DOCUMENT 00 90 00
ADDENDUM

ADDENDUM NO. [2] **Date: June 15, 2020**

RE: WESTERN TECHNICAL COLLEGE
CLEARY COURTYARD BRICK PAVER REPLACEMENT
400 6th STREET NORTH
LA CROSSE, WISCONSIN 54601
HSR PROJECT NO. 20007

WESTERN TECHNICAL COLLEGE
CLEARLY PLAZA
400 6TH STREET
LA CROSSE, WI 54601
DETAILS

C102

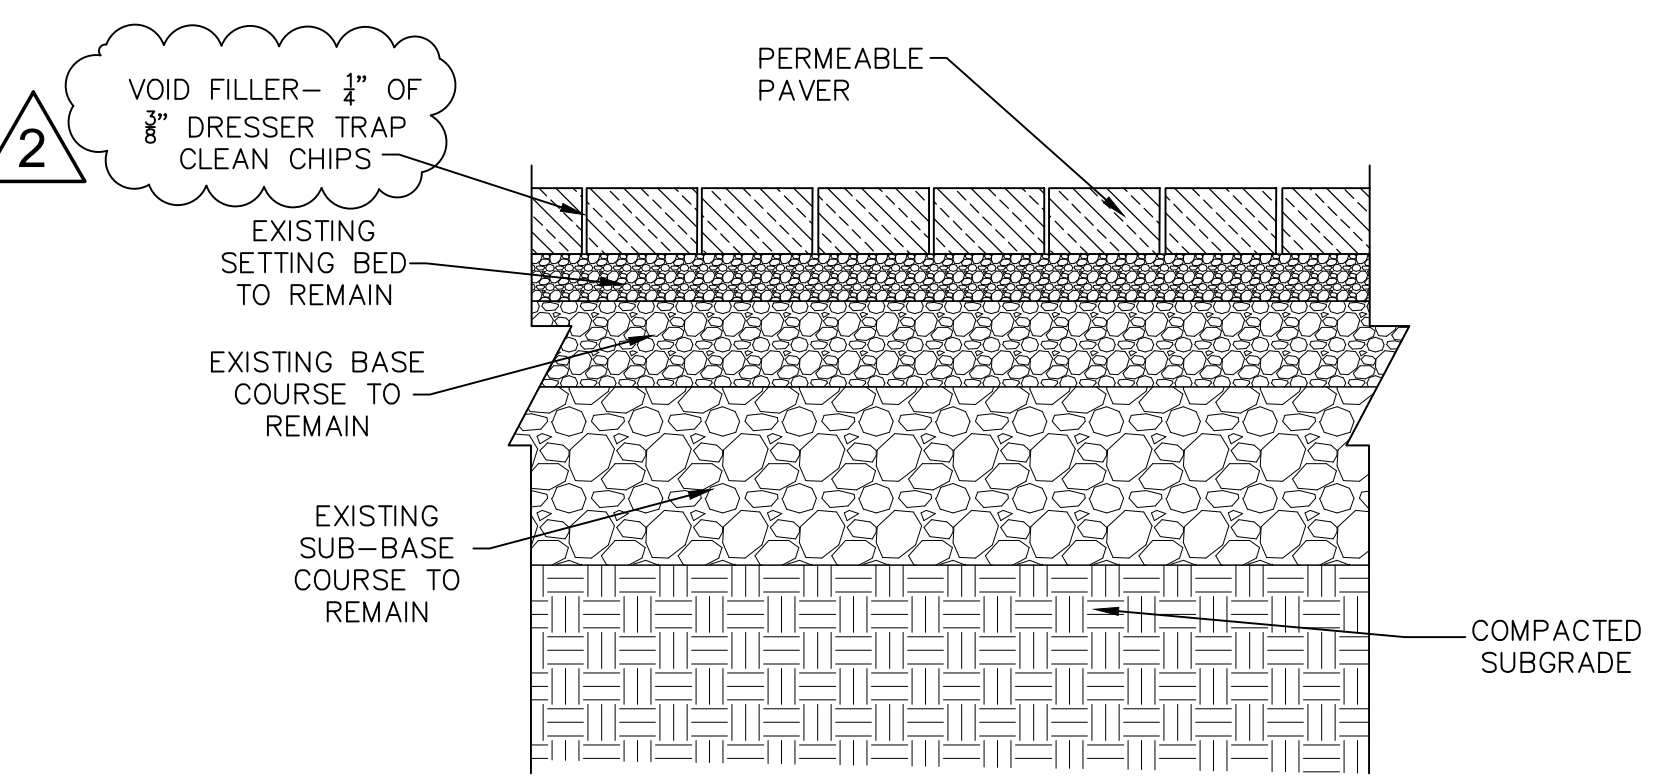
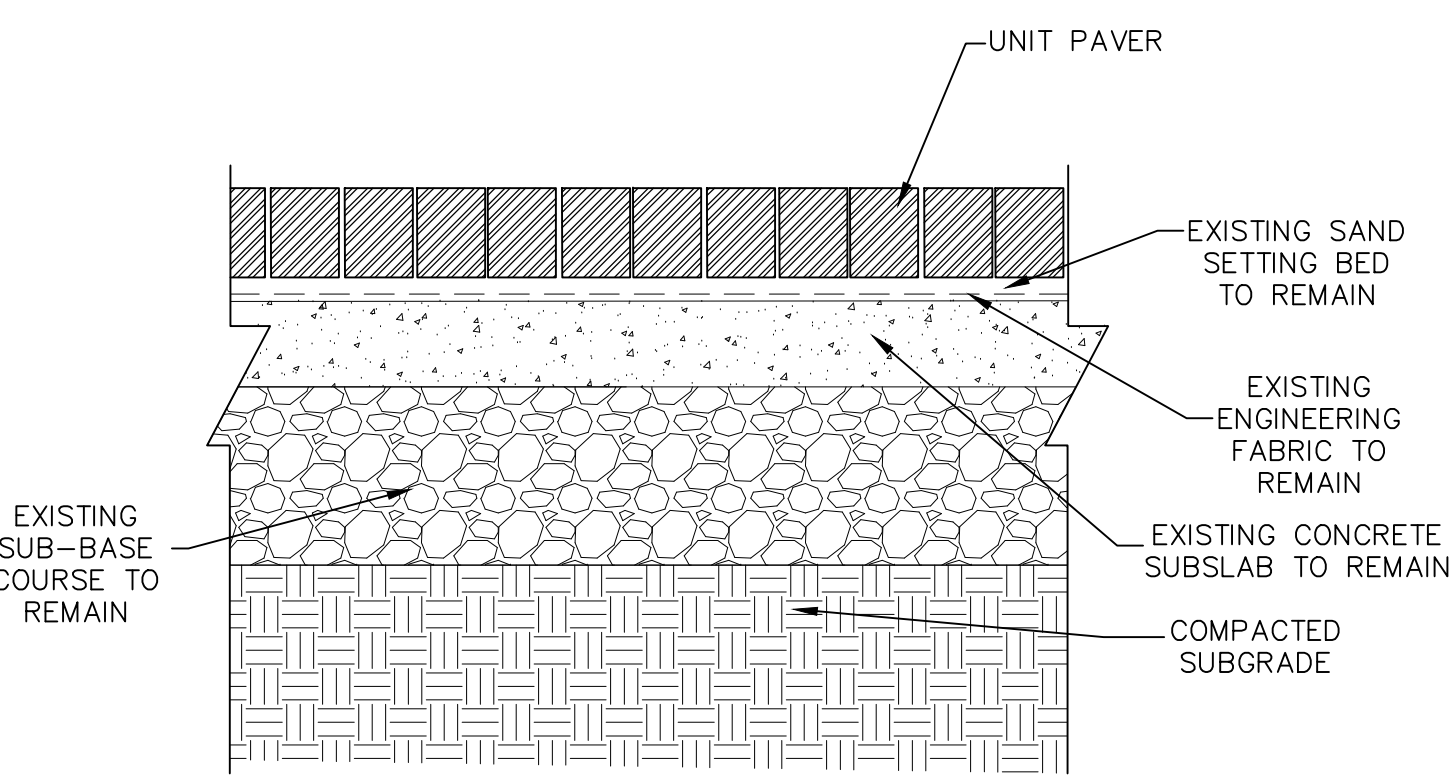
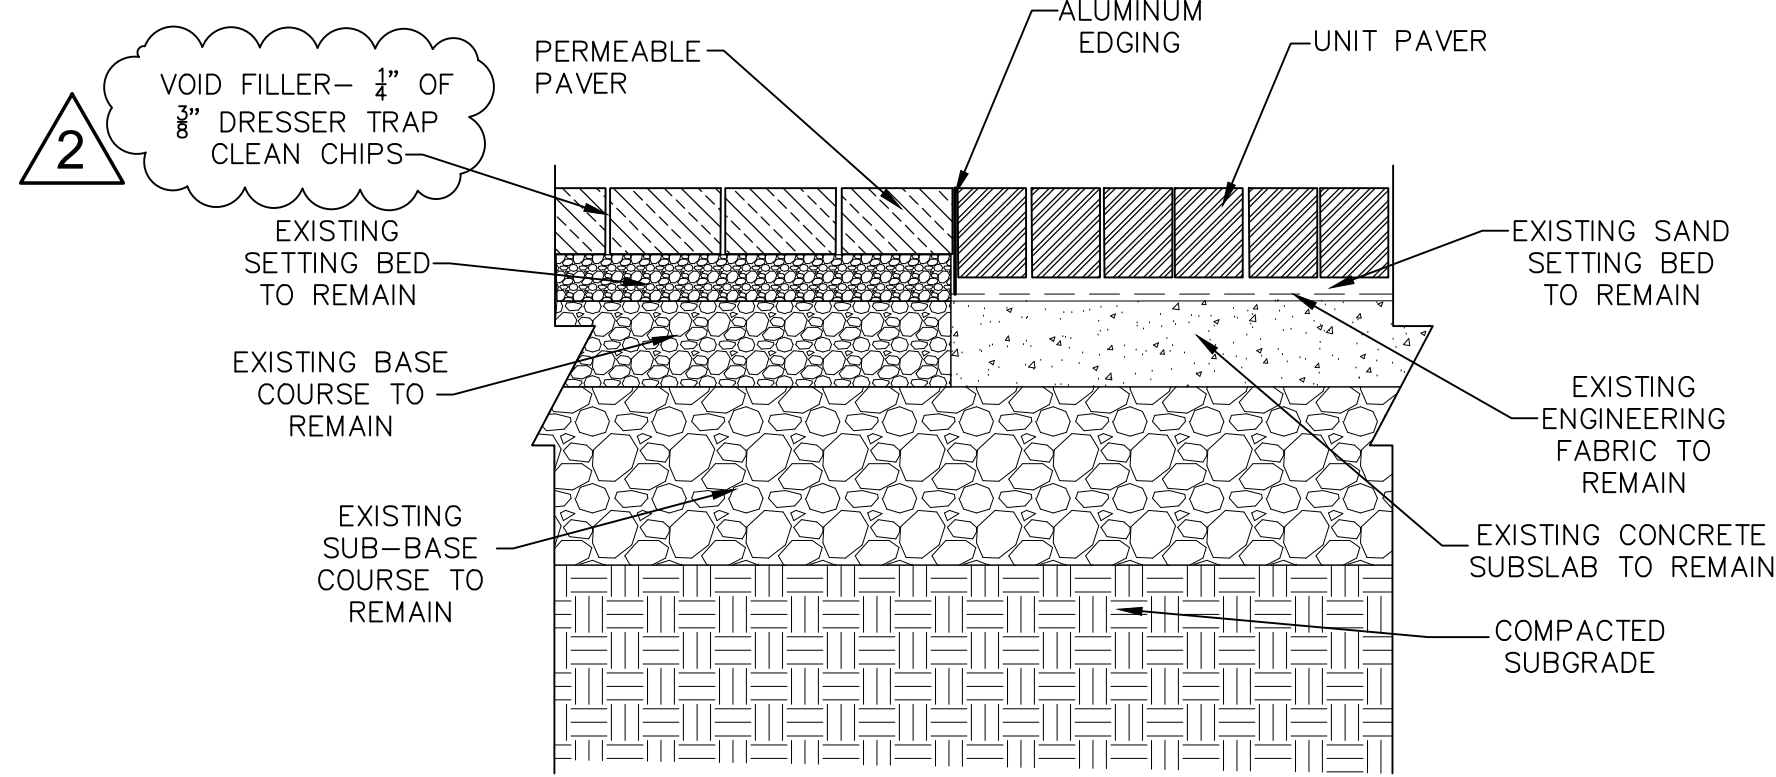
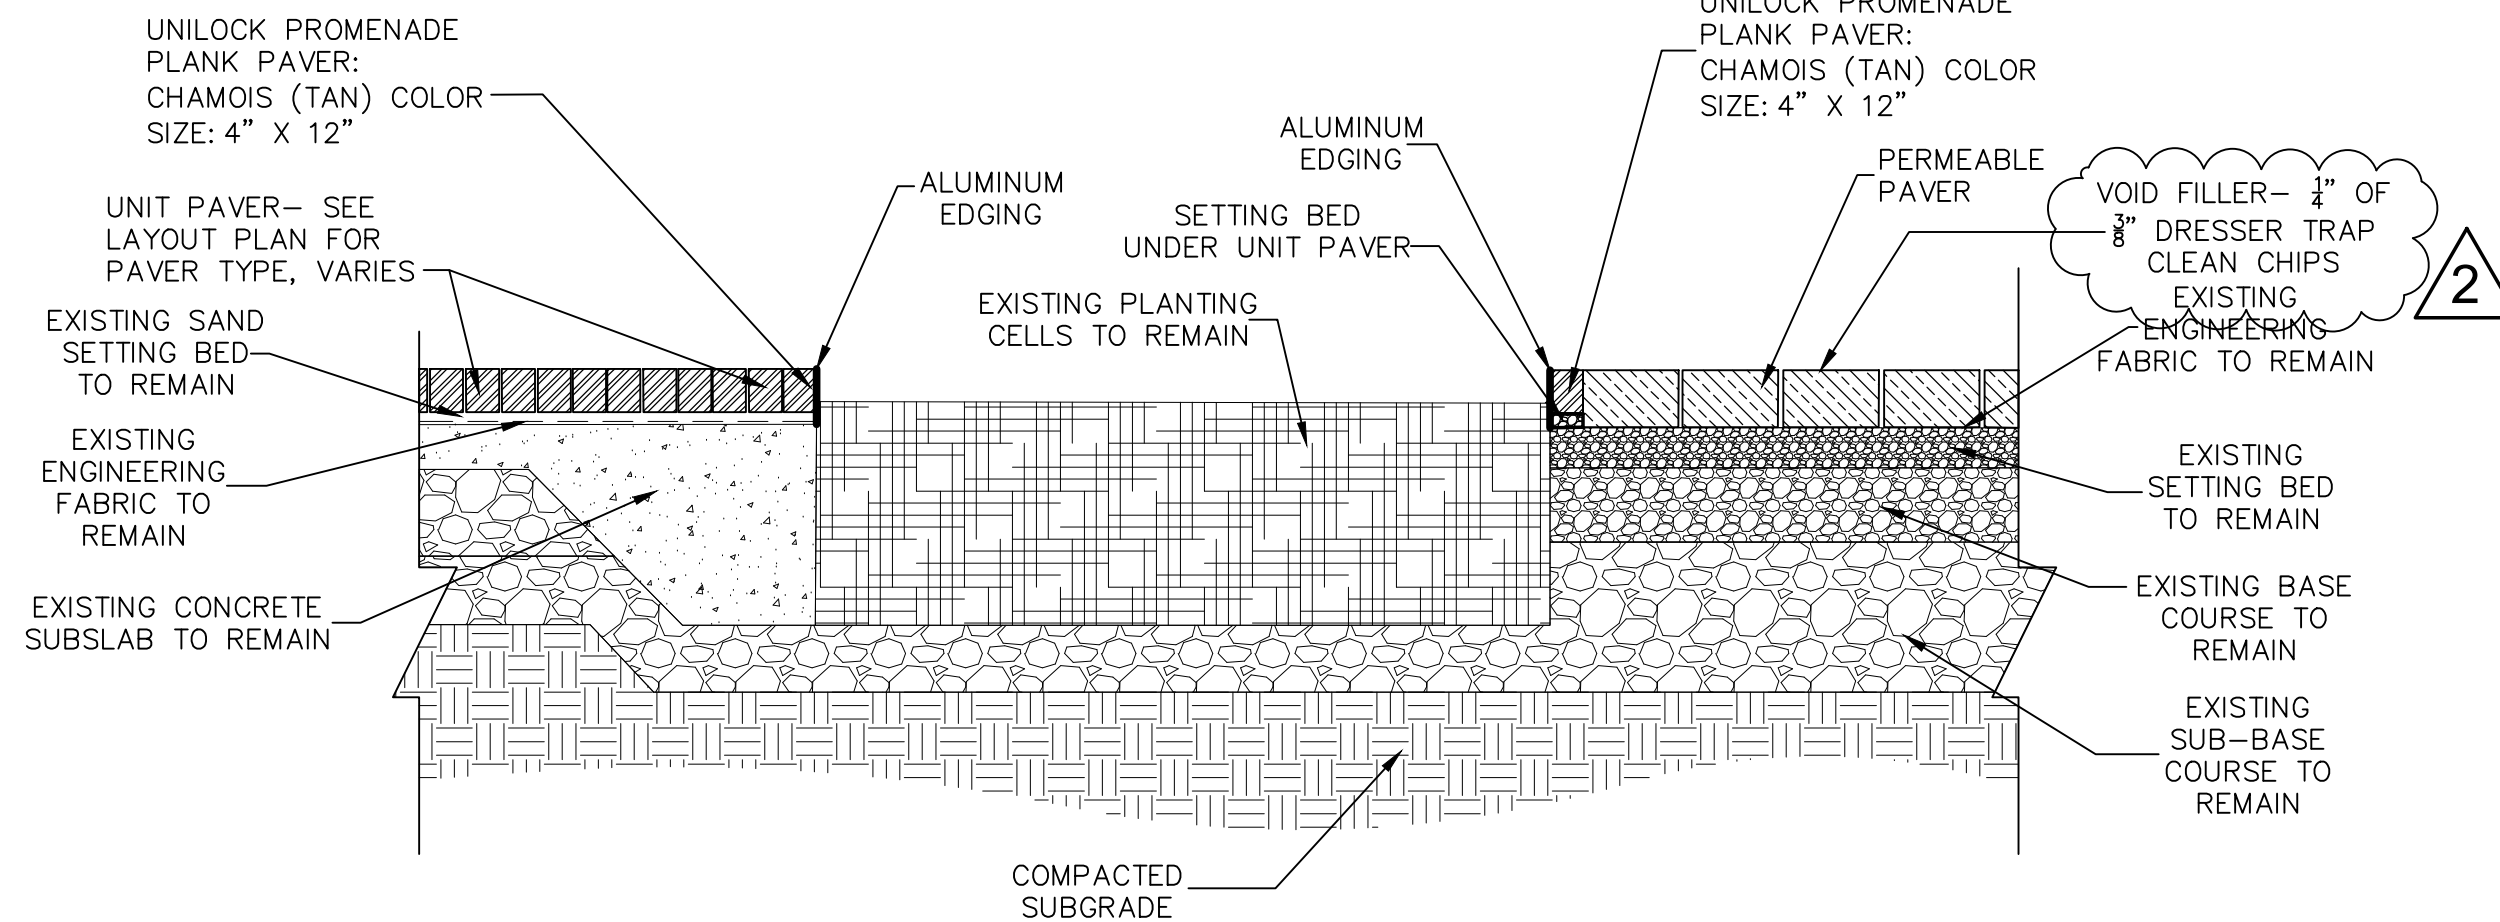
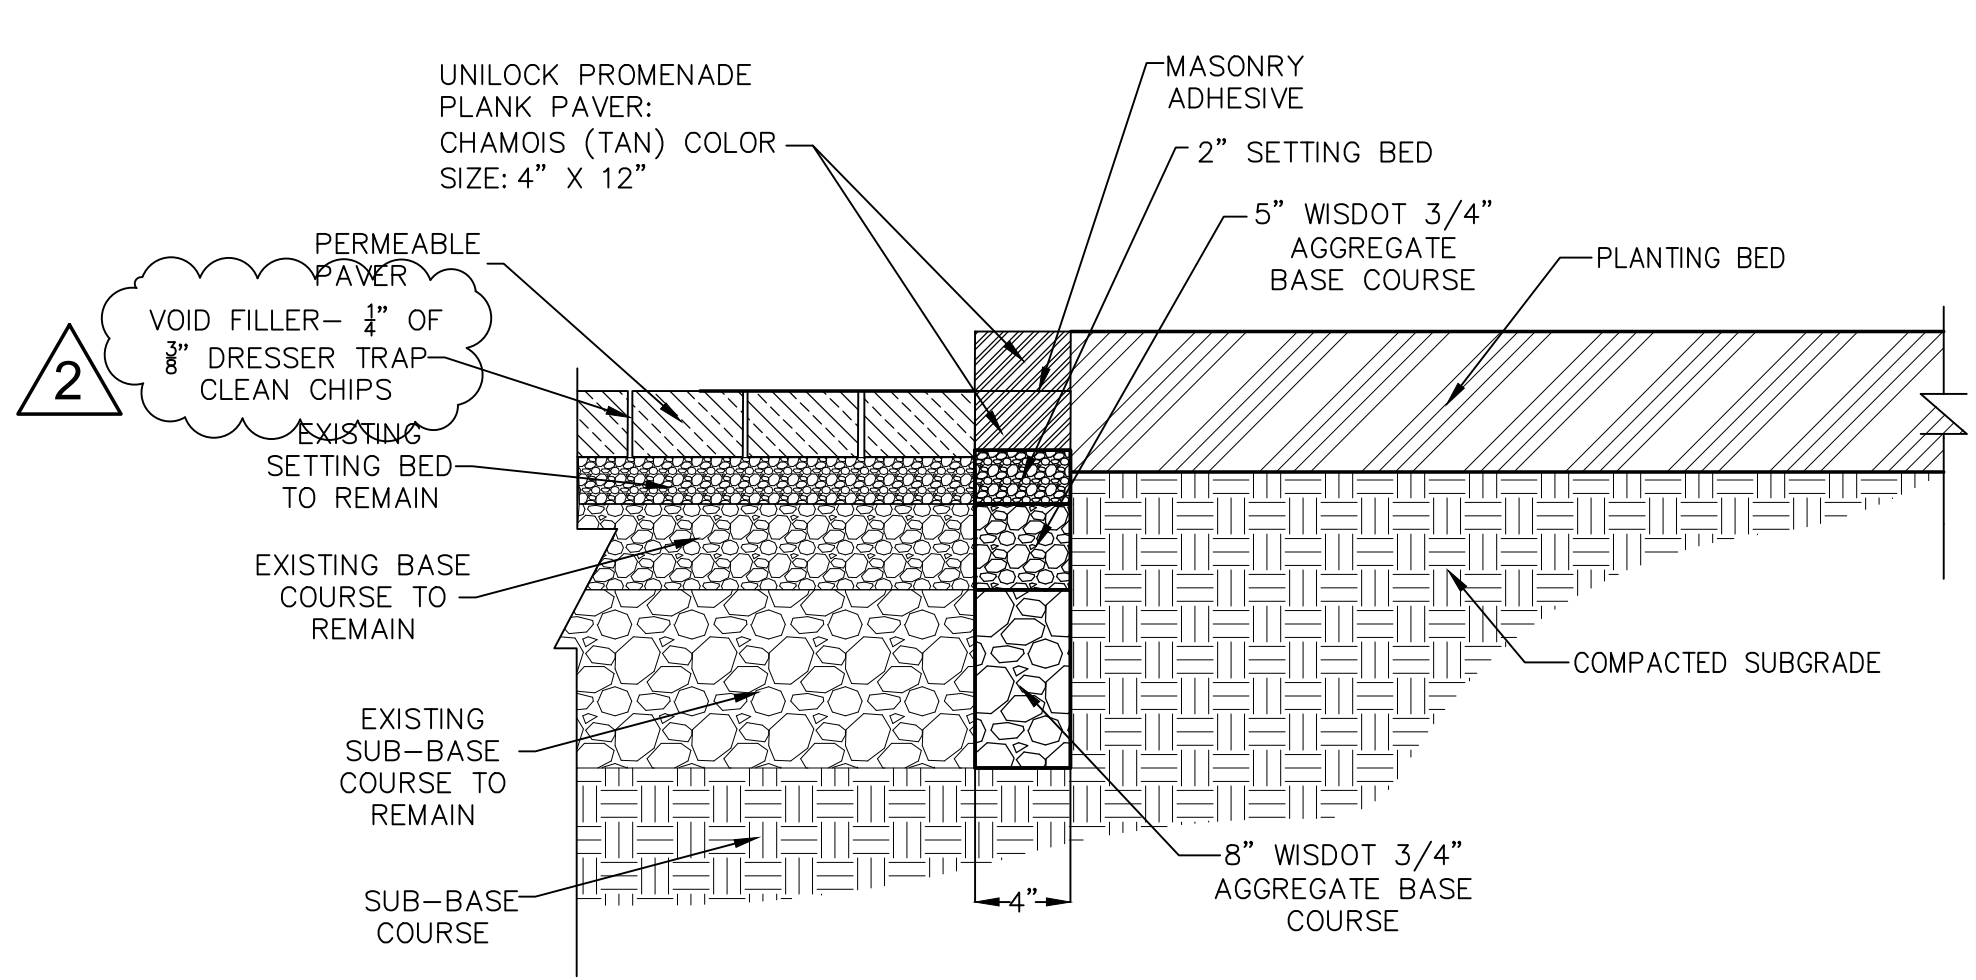
Sieve Size	Percent Passing
3/8 inch (9.5 mm)	100
No. 4 (4.75 mm)	95 to 100
No. 8 (2.36 mm)	80 to 100
No. 16 (1.18 mm)	50 to 85
No. 30 (0.600 mm)	25 to 60
No. 50 (0.300 mm)	10 to 30
No. 100 (0.150 mm)	2 to 10
No 200 (0.075 mm)	0 to 1
 - 7) Engineering Fabric: Acceptable knit fabrics: WS DOT 645.2.4 Geotextile Fabric, Type DF (Drainage Filtration).
6. Sheet C102 DETAILS 30 x 42 attached hereto.
- a. Revisions clouded on Drawing.
